**CALIFORNIA REGIONAL WATER QUALITY CONTROL BOARD
LAHONTAN REGION**

**MEETING OF FEBRUARY 13 AND 14, 2013
South Lake Tahoe**

SUBJECT: **UNITED STATES FOREST SERVICE-LAKE TAHOE BASIN MANAGEMENT UNIT, UPPER TRUCKEE RIVER REACH FIVE (SUNSET STABLES) RESTORATION PROJECT – EXEMPTION TO WASTE DISCHARGE PROHIBITIONS CONTAINED IN THE WATER QUALITY CONTROL PLAN FOR THE LAHONTAN REGION (BASIN PLAN)**

**UNITED STATES FOREST SERVICE–LAKE TAHOE BASIN MANAGEMENT UNIT,
UPPER TRUCKEE RIVER REACH 5 RESTORATION – EXEMPTIONS TO WASTE
DISCHARGE PROHIBITIONS CONTAINED IN THE WATER QUALITY CONTROL
PLAN FOR THE LAHONTAN REGION**

Figure 1.
UPPER TRUCKEE RIVER REACH 5 RESTORATION PROJECT
PROJECT MONITORING LOCATIONS PER PROHIBITION EXEMPTION

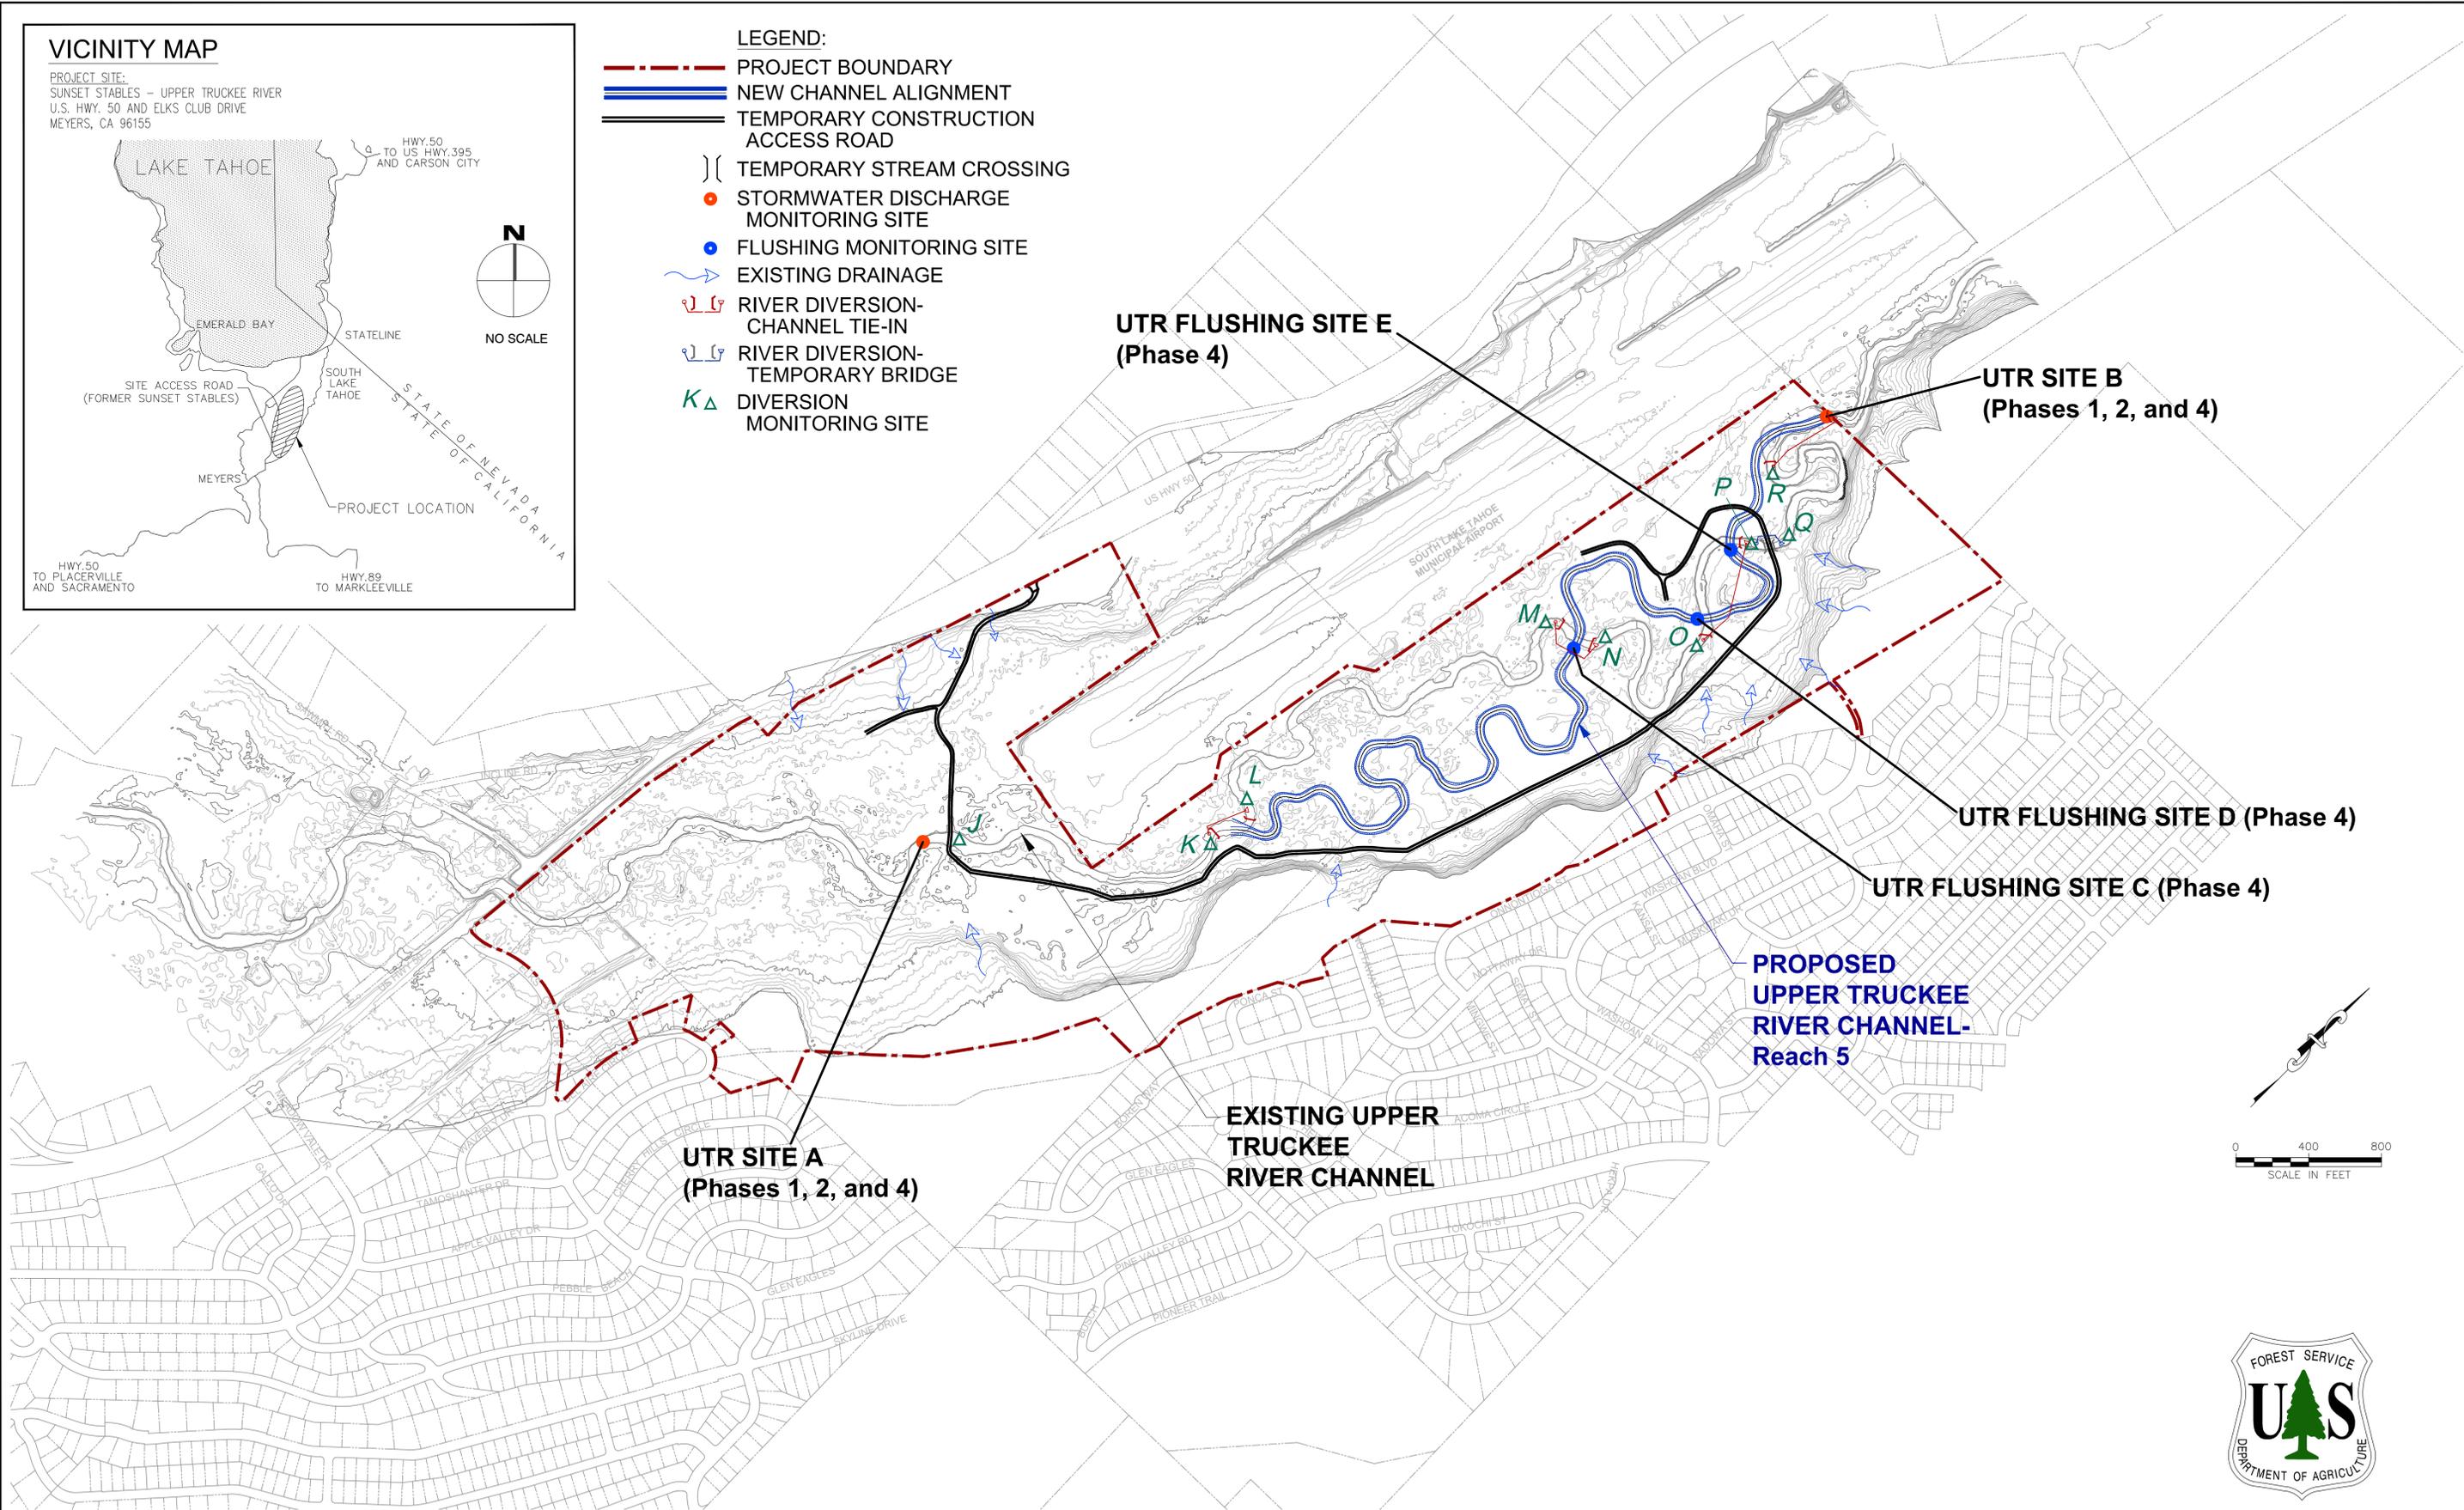
Will continuous turbidity be required above and below construction? If so, then will it so be required in the spring to capture the condition they are designing to? (Spring runoff peak since this is when much of the erosion occurs.

Will the project proponent be required to perform post project water quality monitoring in the spring during peak runoff? Grab or continuous?

4. The project proponent proposes to conduct continuous turbidity monitoring above and below the project area to assess impacts related to construction activities. As proposed in the draft SWPPP, the monitoring is expected to occur during active construction periods, so approximately June-October.
5. The Water Board does not anticipate requiring post-project water quality monitoring. The project proponent has prepared a draft monitoring plan to evaluate long-term project effectiveness to assess the success of the ecosystem restoration effort. This plan is also likely subject to change prior to project approval.
